Section 16 Planning Application for Proposed Minor Relaxation of the Maximum Domestic GFA for the Permitted Residential Development of the Urban Renewal Authority Sai Yee Street/ Flower Market Road Development Scheme (YTM-013) (Planning Application No. A/K3/603)

Responses to Departmental Comments Table

Drawing Title											
MAJOR PEDESTRIAN ROUTE TO / FROM PRINCE EDWARD MTR STATION											
Designed	CHM	Checked	HWL	Scale	NTS	Date	MAY 2024	Drawing No.	APP1	Rev.	-

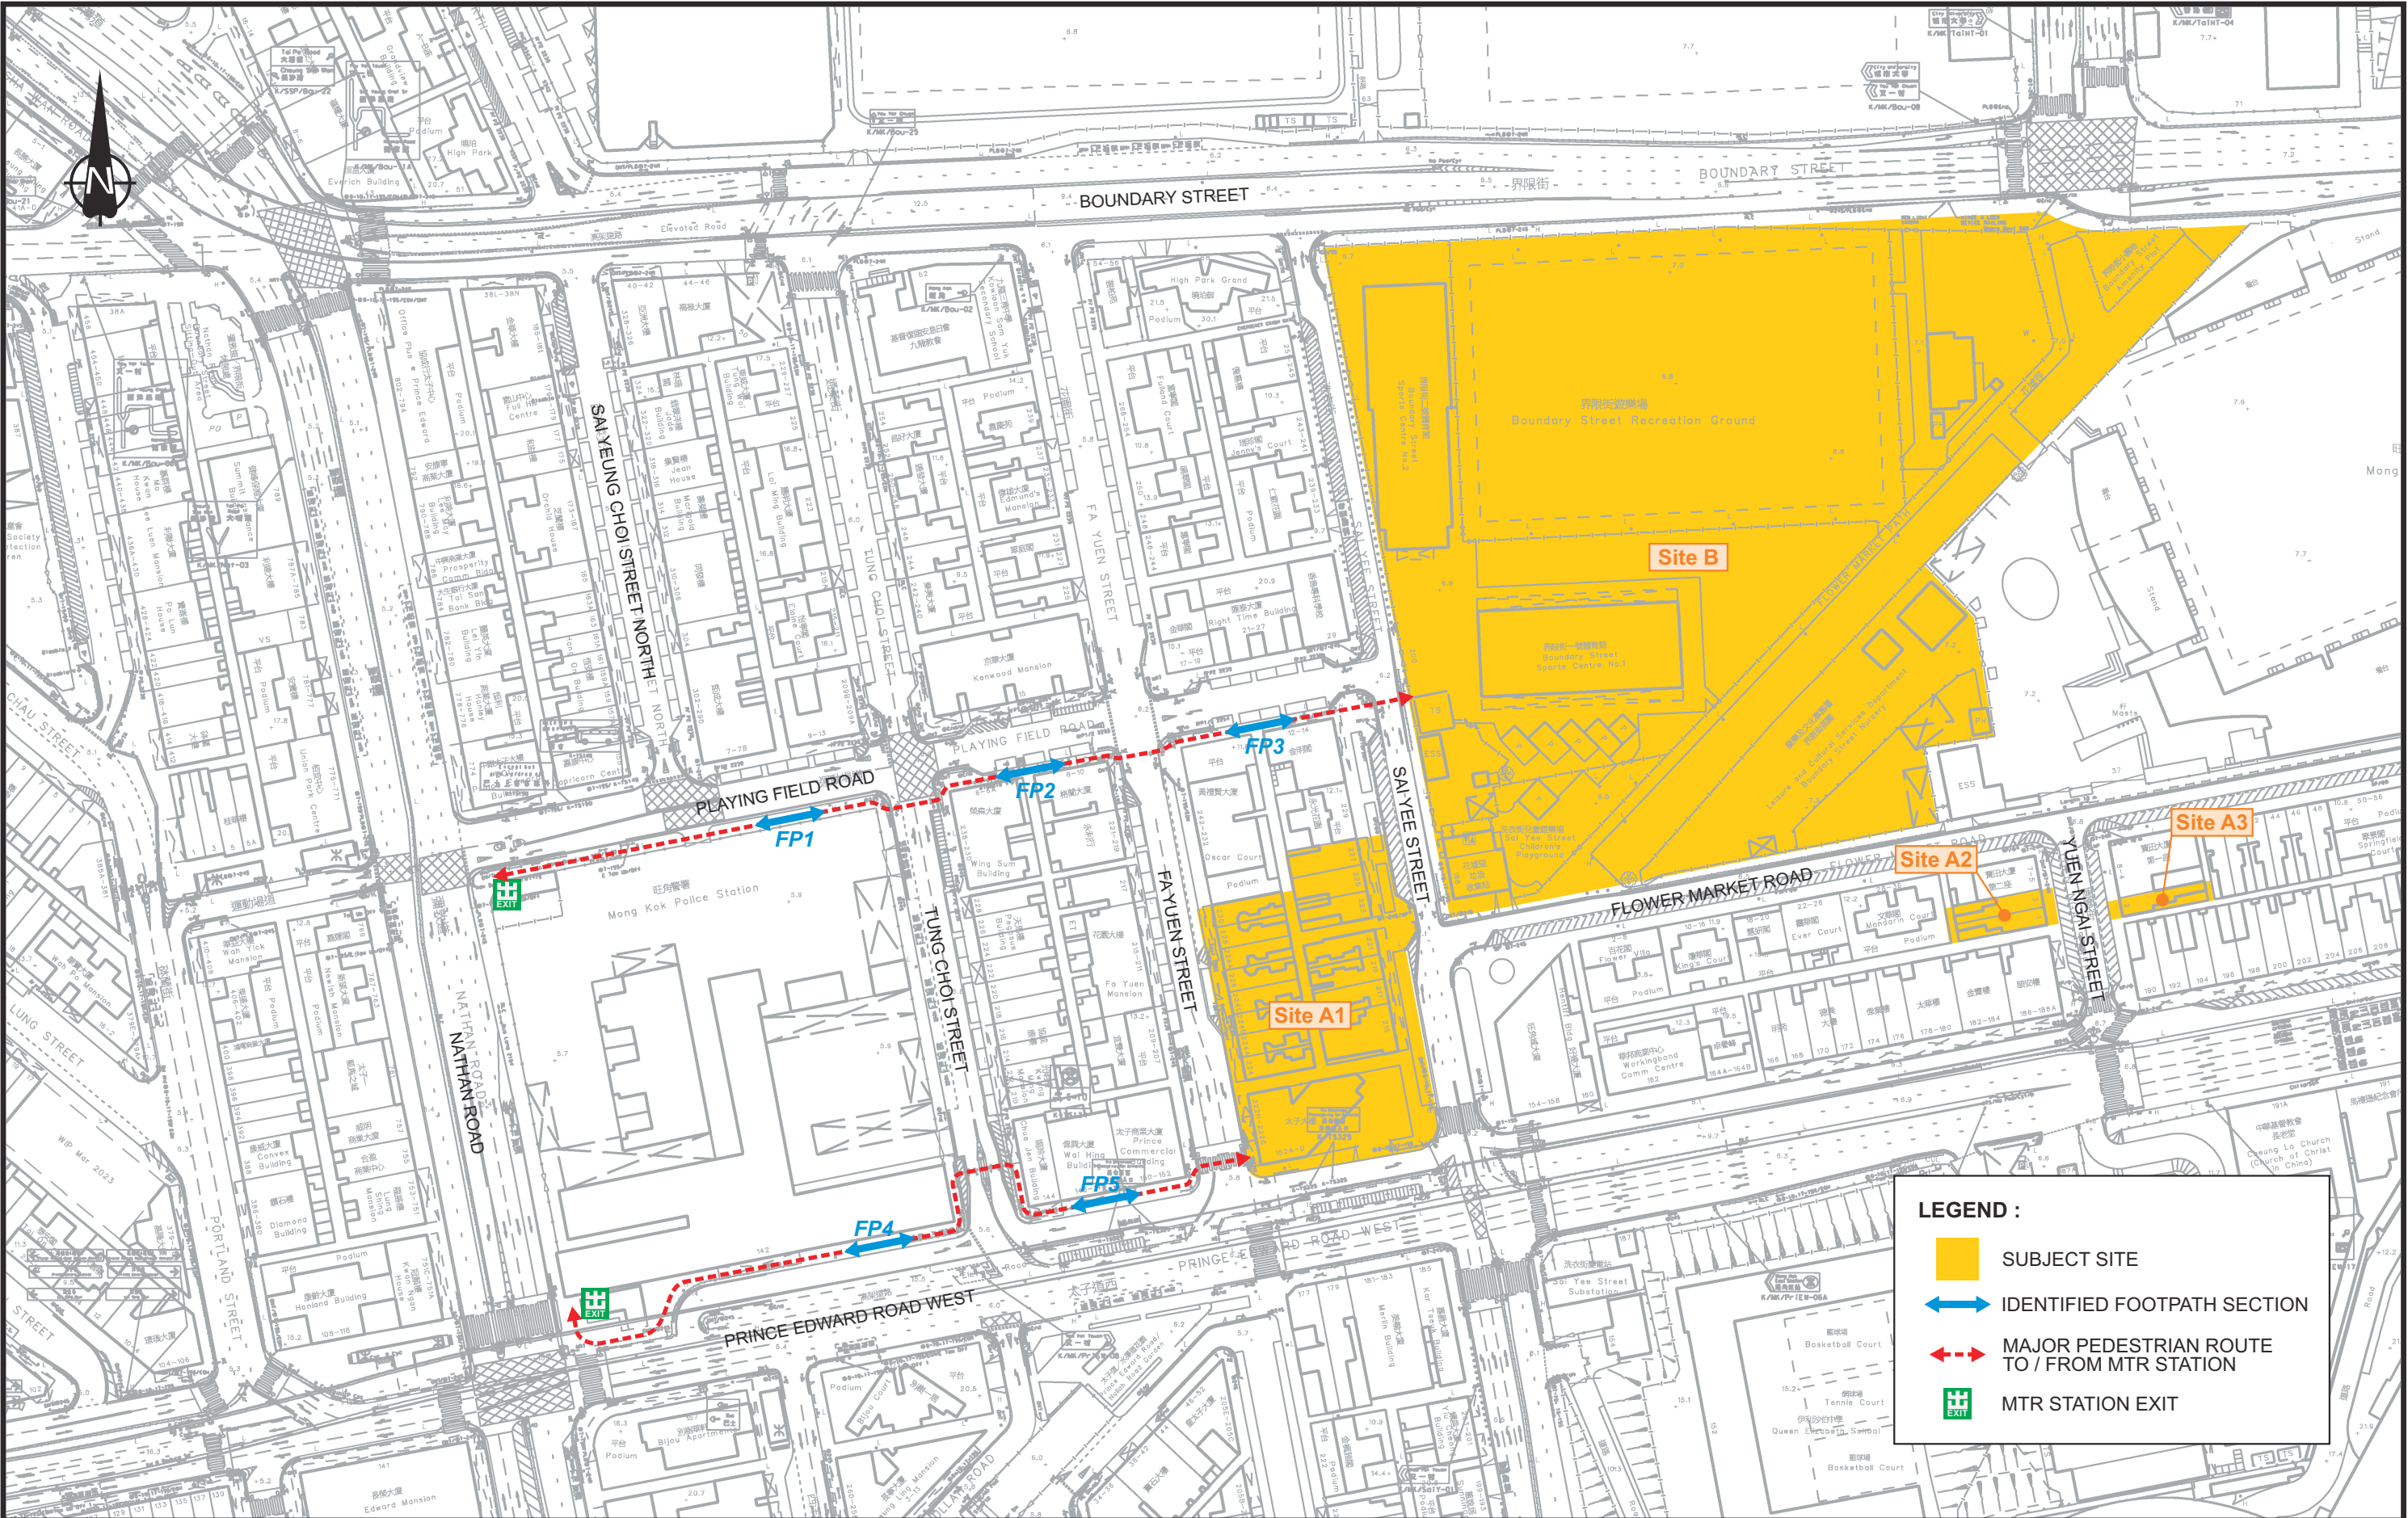
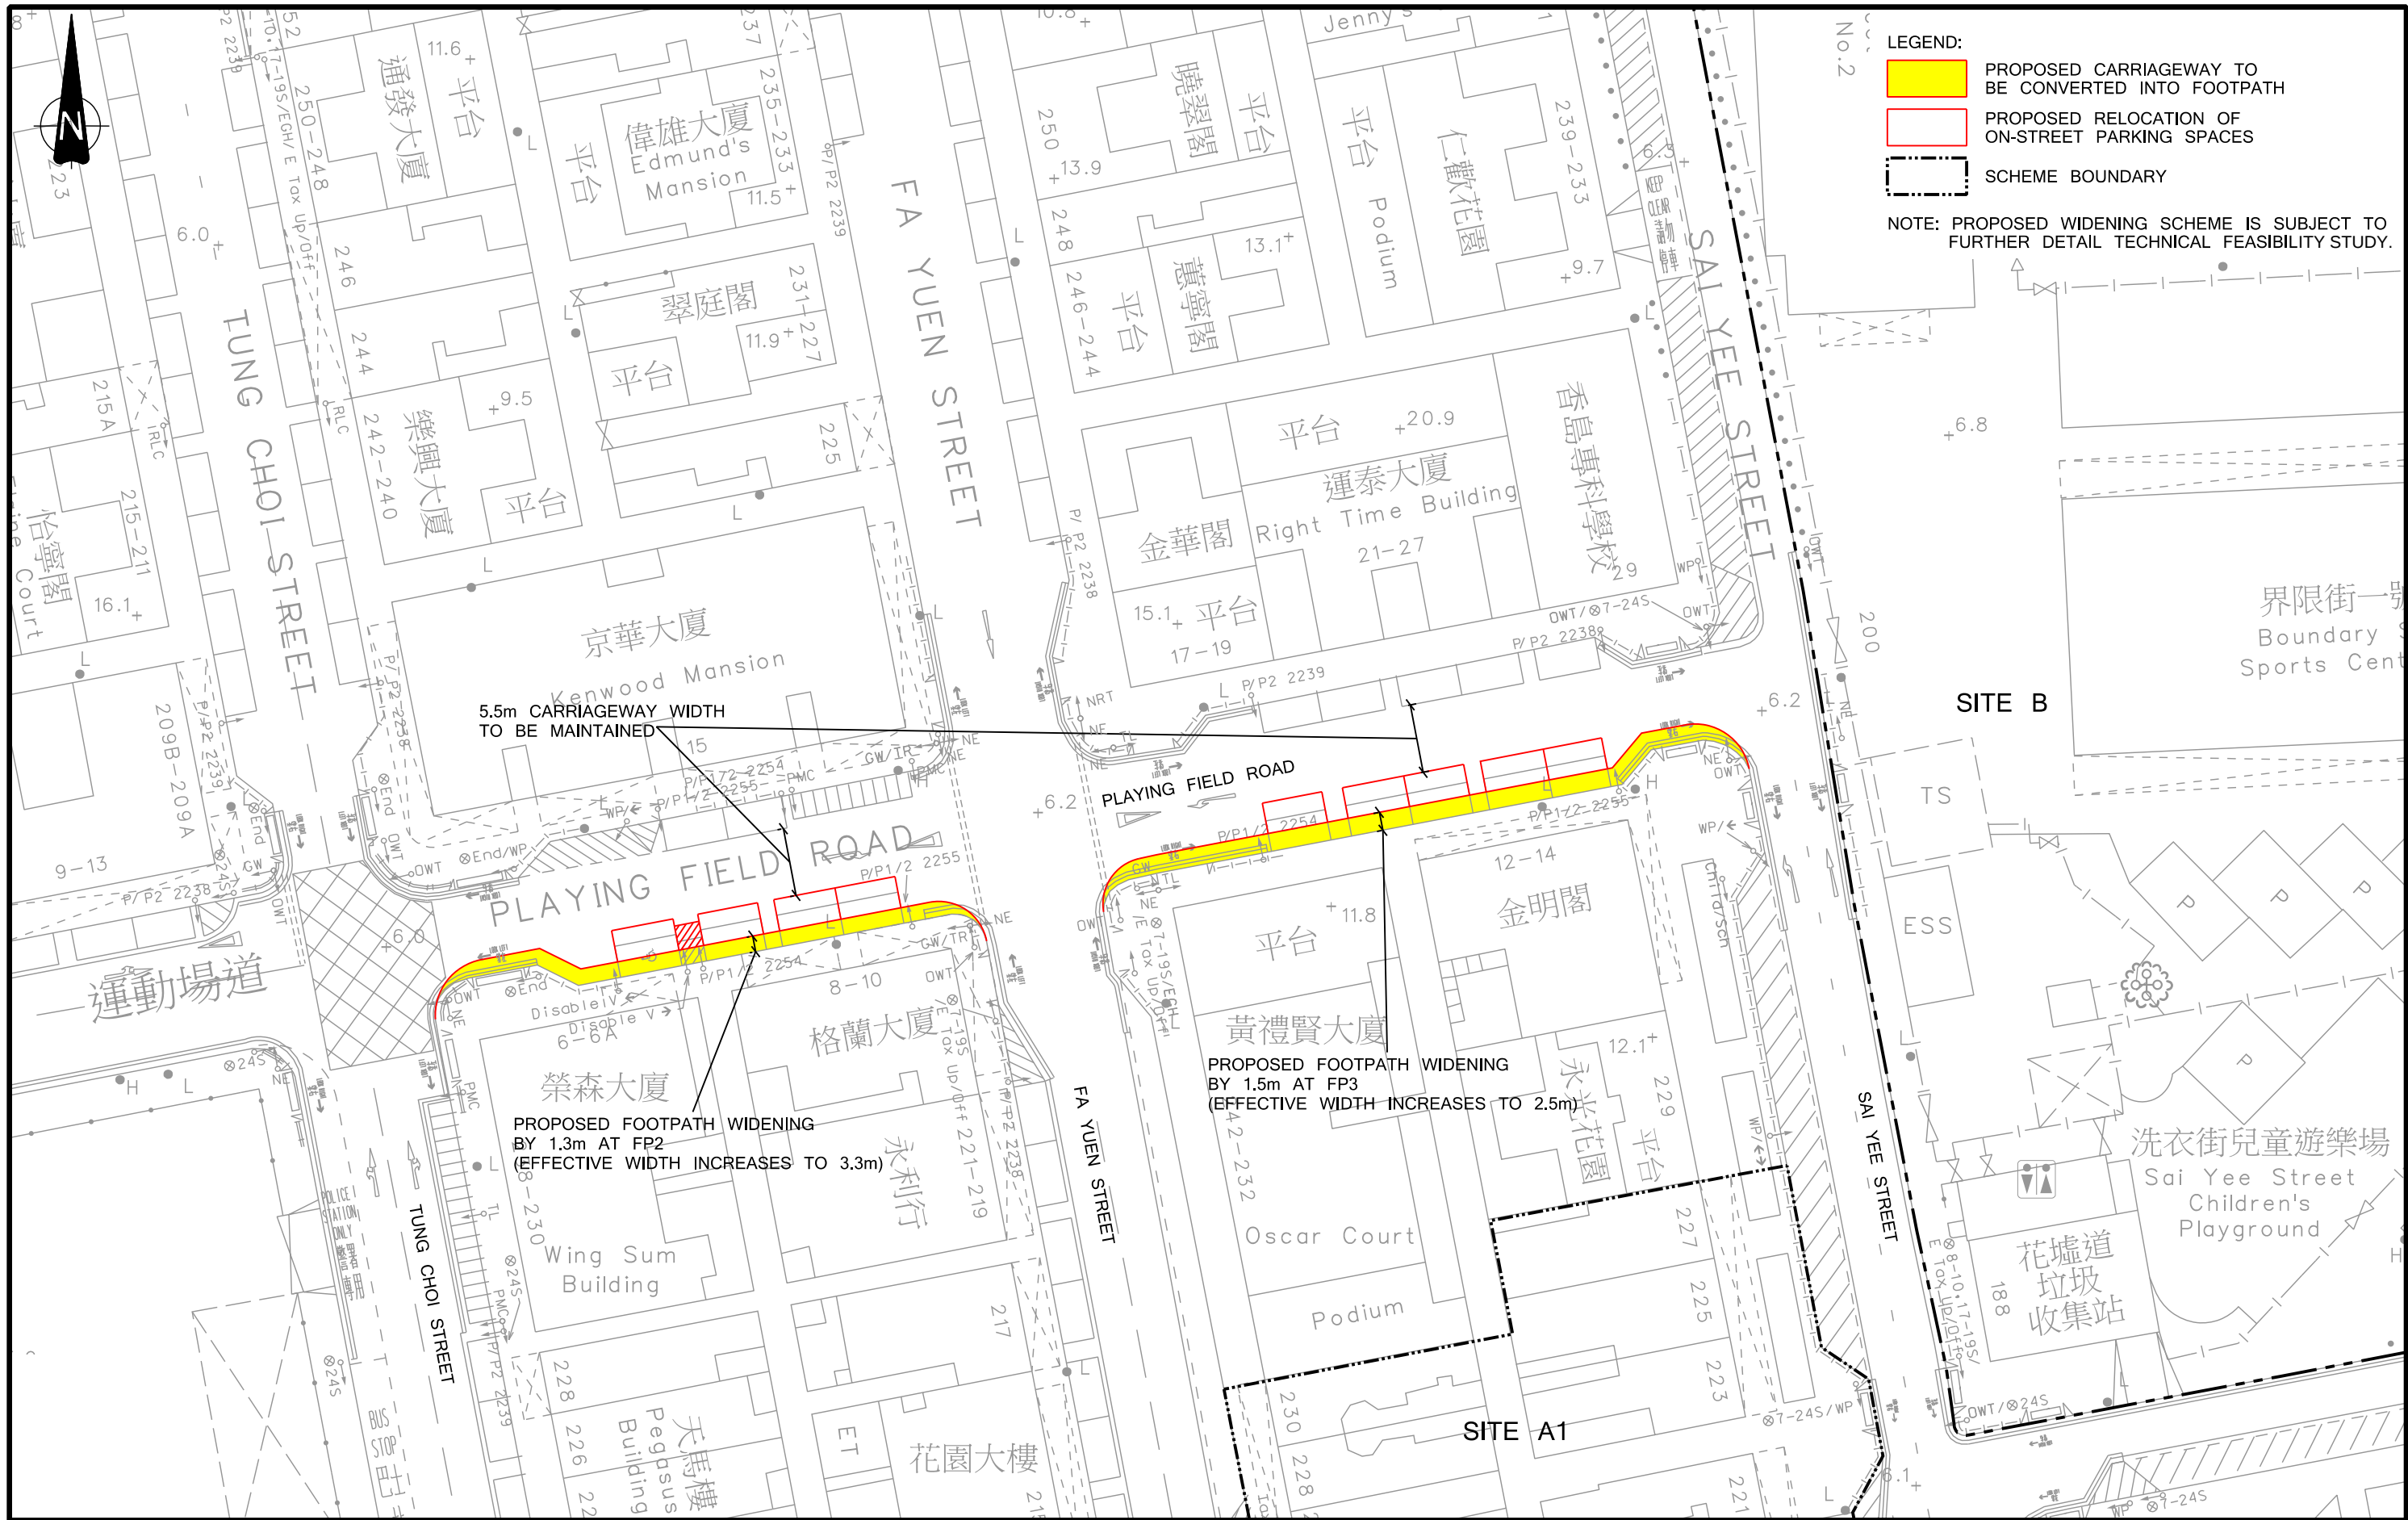
Departmental Comments	Responses																																																																								
	widening is also proposed widening along part of Playing Field Road which was identified as another major pedestrian route to Prince Edward MTR Station. The Supplementary LOS Assessment is appended to this TIA for reference and is separate from this S16 Planning Application. Section 5.2.8 of the TIA report (See Appendix 3) is supplemented accordingly. The final design and implementation of the proposed pedestrian improvement measures will be determined at detailed design stage and are subject to agreement with TD and other relevant Government departments.																																																																								
(g) Please note the updated information on public transport services as follows: Franchised Bus

- 2.1.3 It is proposed to widen the footpath at FP2 and FP3 by reducing the carriageway width into 5.5m as shown in **Drawing No. APP2**. The road width for one-way carriageway is made reference to Transport Planning and Design Manual Volume 2 Chapter 3.4, such that carriageway width of one-way traffic at service roads for all vehicles is 5.5m which is sufficient for normal operation. The proposed scheme details at FP2 and FP3 are summarized in **Table APP-7**.
